CITY OF COSTA MESA

**RE: ZONING APPLICATION ZA-12-10
MINOR CONDITIONAL USE PERMIT TO CONVERT A PORTION OF A
BUILDING CONTAINING A DRIVE-THROUGH FOR A FORMER CREDIT
UNION TO A DRIVE-THROUGH FOR A COFFEE SHOP
450 EAST 17TH STREET, COSTA MESA**

**Subject: Response to Appeal Comments by Toby Walker
Approval of Zoning Application ZA-12-10
Remodel and Tenancy Modification for Former Orange County
Teacher's Federal Credit Union (OCTFCU) Site
450 E. 17th Street
Costa Mesa, California**

SITE PLAN

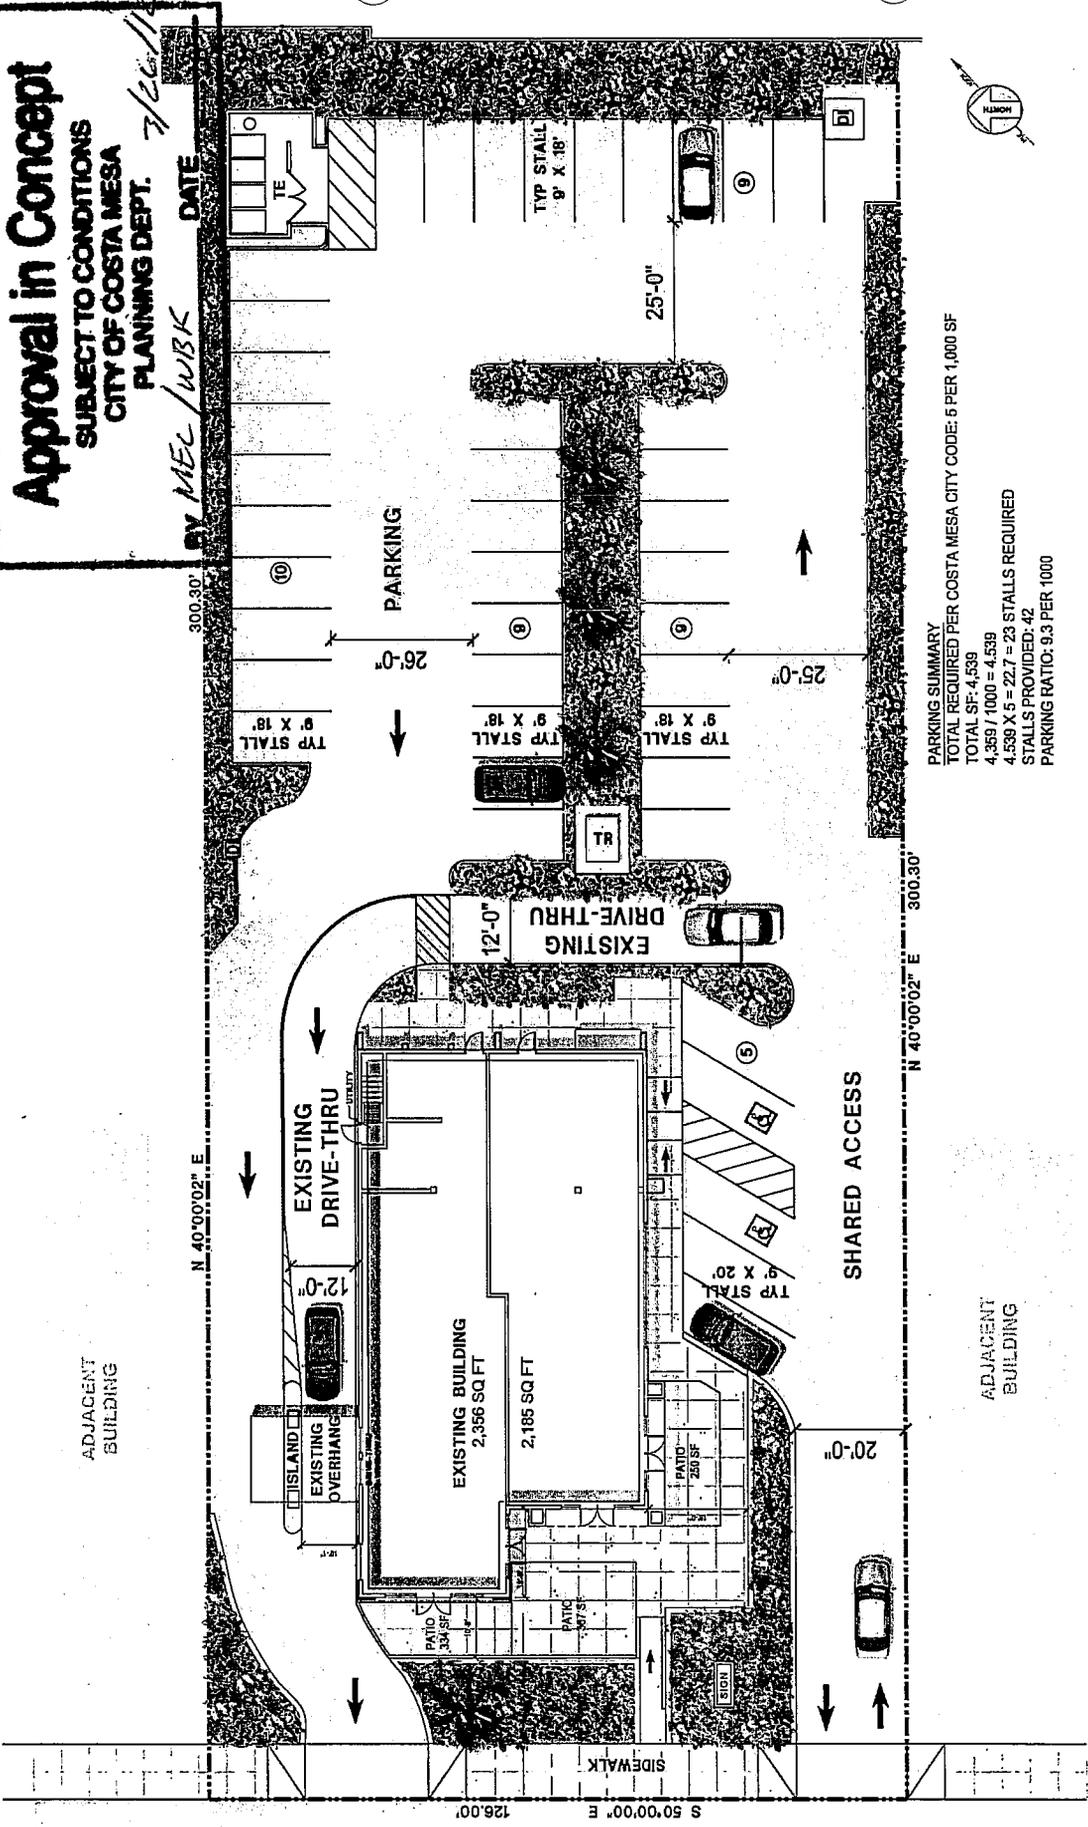
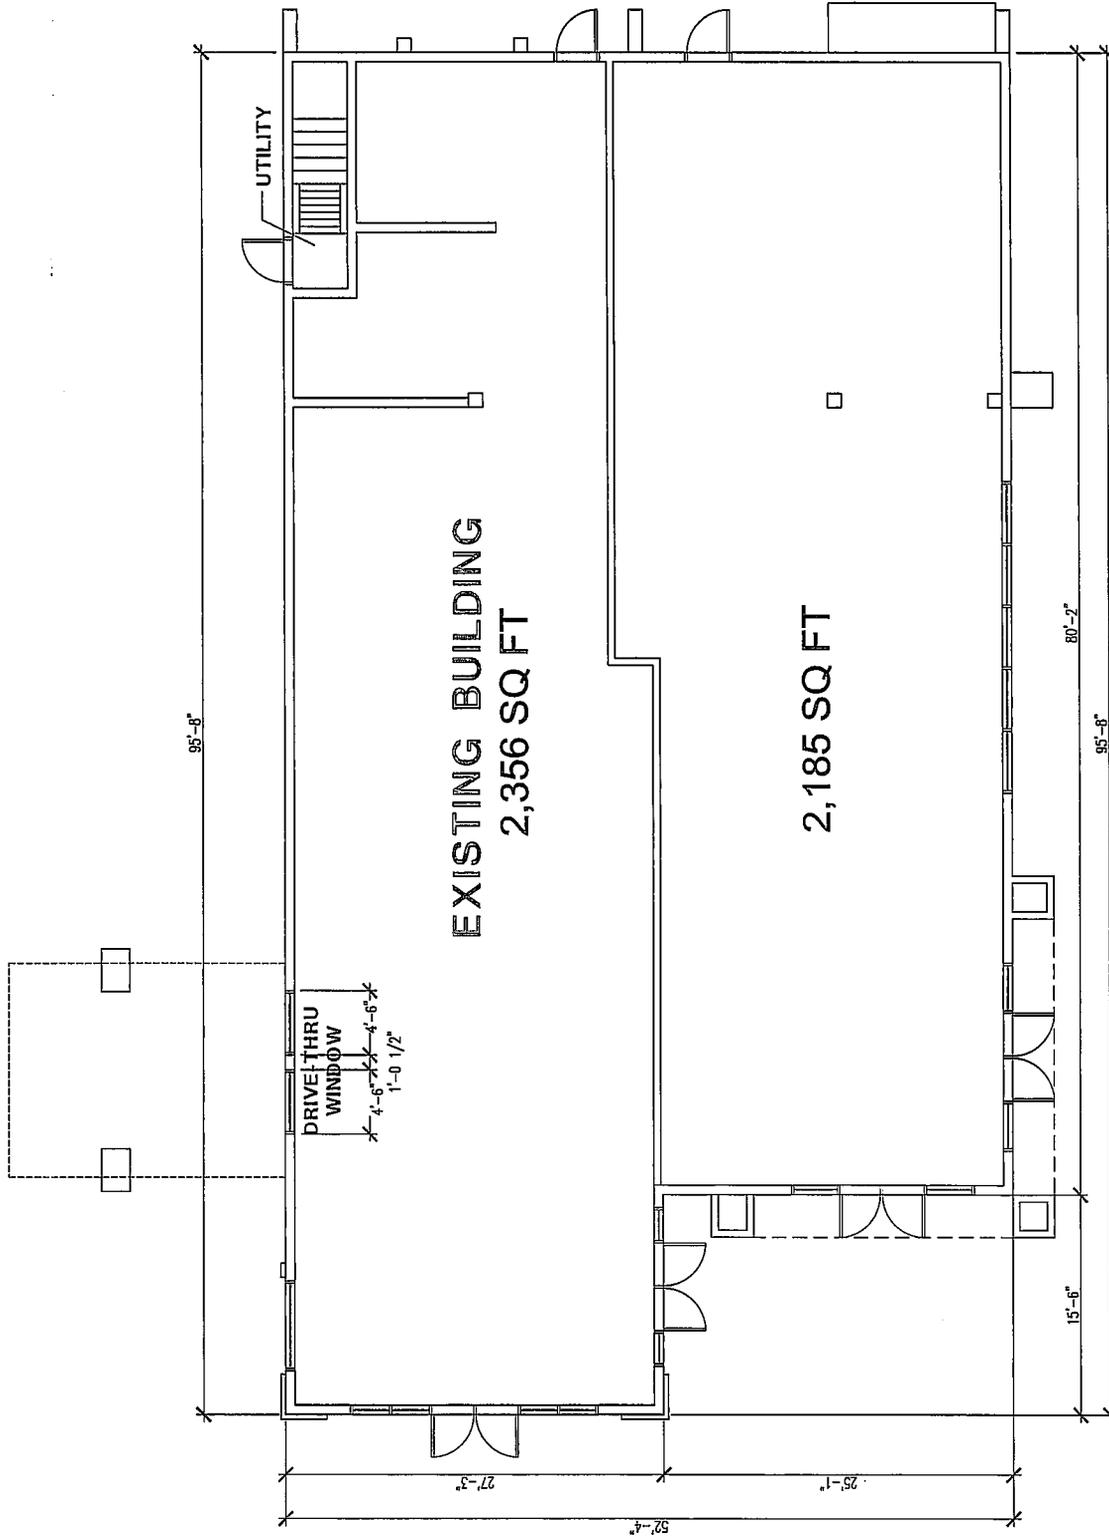
The conceptual plans show the proposed patio located within the required street landscape setback. Staff has included a condition of approval requiring that the applicant work with staff to reconfigure the proposed outdoor patios to minimize the encroachment into the required street setback landscape planters, subject to approval by the Planning Division.

14. The applicant shall work with staff to reconfigure the proposed outdoor patios to minimize the encroachment into the required street setback landscape planters, subject to approval by the Planning Division.

FUTURE CONDITIONS "SNAPSHOT"
450 AND 462 EAST 17TH STREET, COSTA MESA

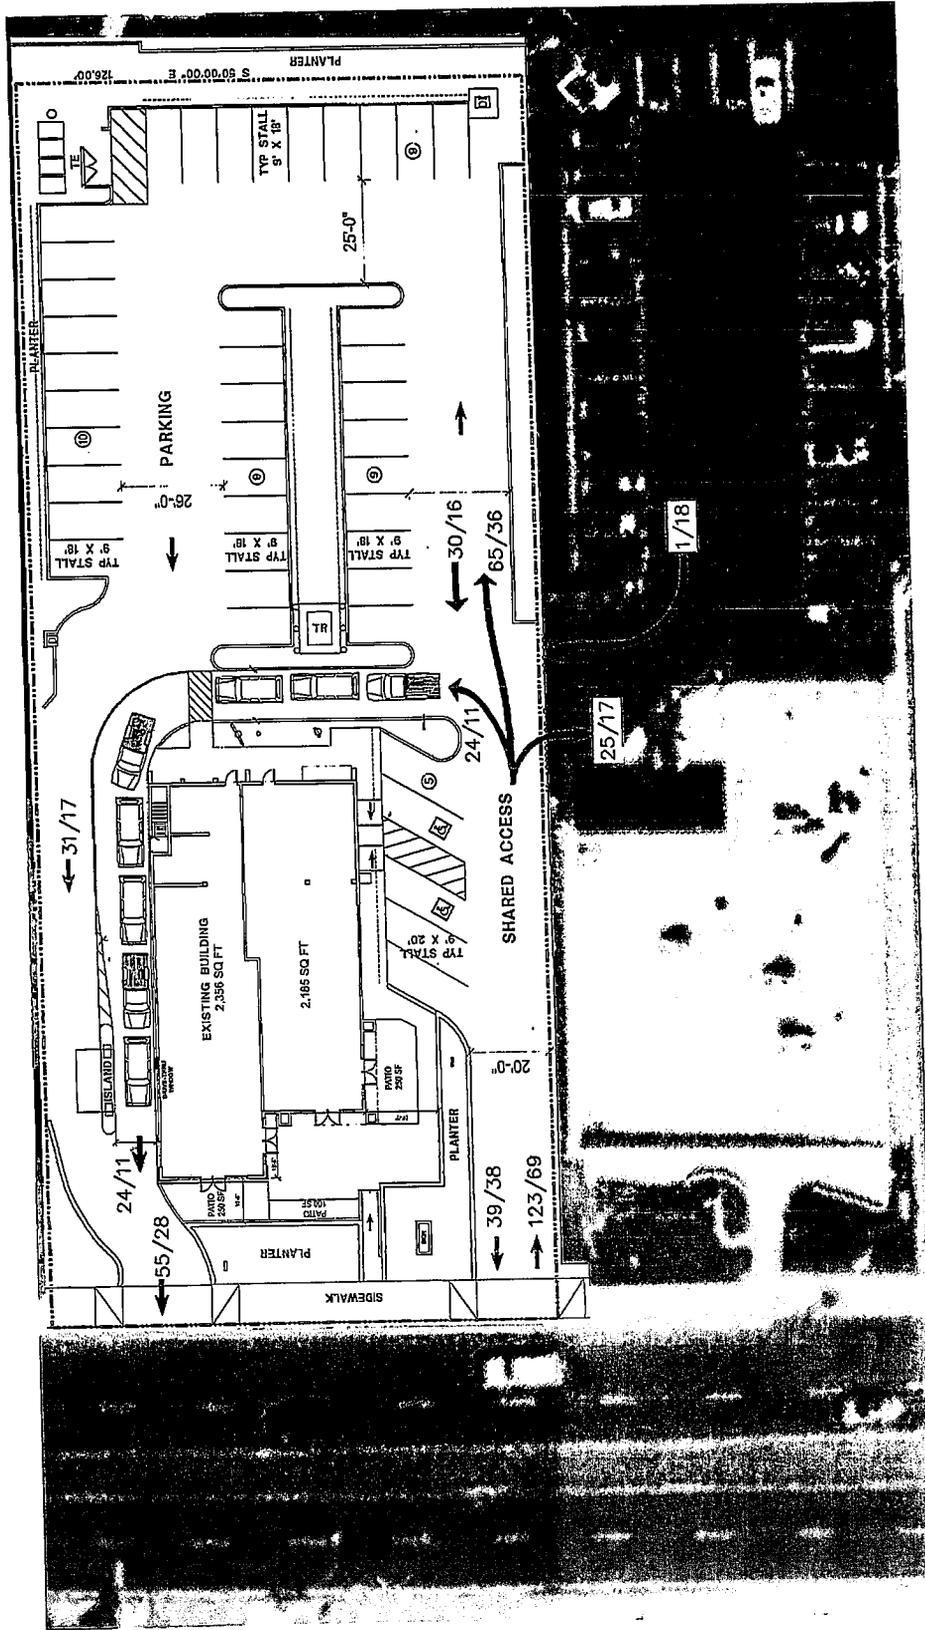
Of critical importance, the current site plan causes all of the following ingress-egress activities to simultaneously occur in the same area, thereby causing a confluence" of conflicting vehicle movements:

It is common for a mix of internal traffic flow patterns to “share” a common “footprint” within an on-site circulation configuration. While referred to as a confluence, the area described in the comment is really an internal “T” intersection (there are three “legs” with approaching traffic) with a fourth leg carrying only “leaving” intersection traffic as it enters the drive-thru lane. In this case, the “stem” of the “T” would be the exiting movement from the “462” parking lot, and as the side approach, that movement would normally be subject to STOP control. It is expected that the north-south movements along the aisle would not be subject to STOP control.

Figure 2 illustrates forecast future volumes based on the existing traffic counts plus adjustment for full occupancy at “462” as well a full future occupancy at “450”. In considering the above comment, it is important to understand not just the pattern of flows but the expected volume on each movement. Based on the *Figure 2* peak hour volume projections, it can be concluded that future traffic volumes at this internal intersection will be consistent with its overall design configuration including the presence of a possible STOP control on the “462 side street” approach.

- a) The *Figure 2* volumes along the easement are consistent with a two-lane parking lot drive aisle including one with 20’ overall width. The *peak hour* northbound (entering) volume equates to an average flow rate of roughly 1 to 2 vehicles per minute. The *peak hour* southbound (exiting) movement equates to a rate of less than 1 vehicle per minute. While clearly measurable, these volumes are not large and clearly within the capabilities of this traffic configuration.

- c) Given the volume projections discussed above, with the further clarification in *Response a* above, significant issues are not anticipated.
- d) The *Figure 2* "snapshot" indicates an AM peak hour drive-thru lane volume of 24 vehicles per hour (representing the morning "surge" of Starbucks customer traffic). All of these vehicles would arrive in the drive-thru lane by making a left turn within the site. That left turn would have an "opposing" southbound volume (leaving the "450" parking lot and headed towards 17th Street) of 30 vehicles per hour. On a volume basis alone, we conclude that the potential for conflict is minimal.

Also from *Figure 2*, the overall stacking (queuing) capabilities of the drive-thru lane totals eight vehicles (three to the order board and five vehicles from the order board to the service window). From prior research of "fast food" sites, this stacking length provides sufficient storage distance for at least the 85th percentile confidence level. On that basis, a standing queue as stated in the comment is unlikely and would certainly not represent a common condition. It is acknowledged that the available storage at the order board might be infrequently exceeded, but enough periods of lesser demand would permit those instantaneous peak demands to clear. Additionally, it has been observed that queuing at drive-thru lanes tends to be self regulating. That is, arriving customers at the site will evaluate whether it would be faster to enter the drive-thru, or park their car and walk in. Further, operators like Starbucks are keenly aware of the experiences at their competition, and are therefore focused on delivering the best possible service times to their guests, which in turn translates to managed queue lengths.

Exhibit 6
Source: Walker Appeal

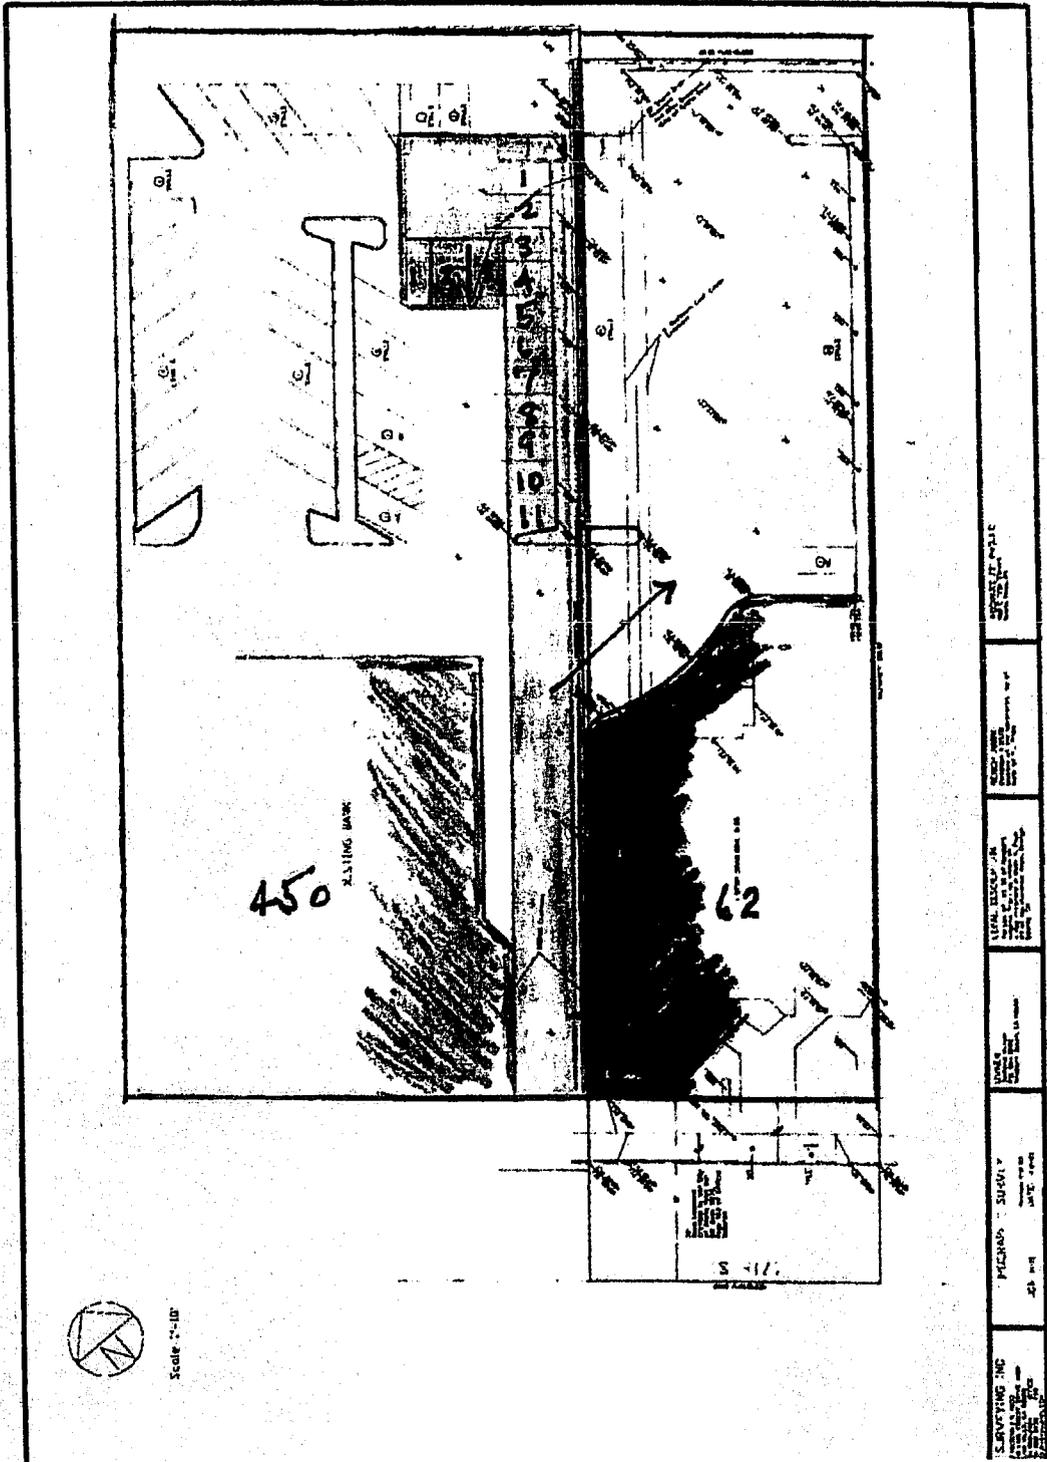
Figure 6 is also from Mr. Walker's package with the mark-up of the plan presumably by Mr. Walker. The figure uses an unknown base which appears consistent with the existing parking and circulation configuration of the site. The area in green exactly corresponds to Parcel 1 of the easement. The location of the 3 spaces in the red-shaded area corresponds to Parcel 2 of the easement.

they are not shown on the proposed plan. If the spaces in green were added, “red” spaces 1 through 3 would be in direct conflict with “green” spaces 3 through 5; they could not function together. Additionally, it is important to note that the areas depicted in red and green are not exclusive easements. So while the easement details are important, the easement and adjoining areas should function cohesively, and the proposed site plan will take steps to correct the shortcomings of the existing configuration.
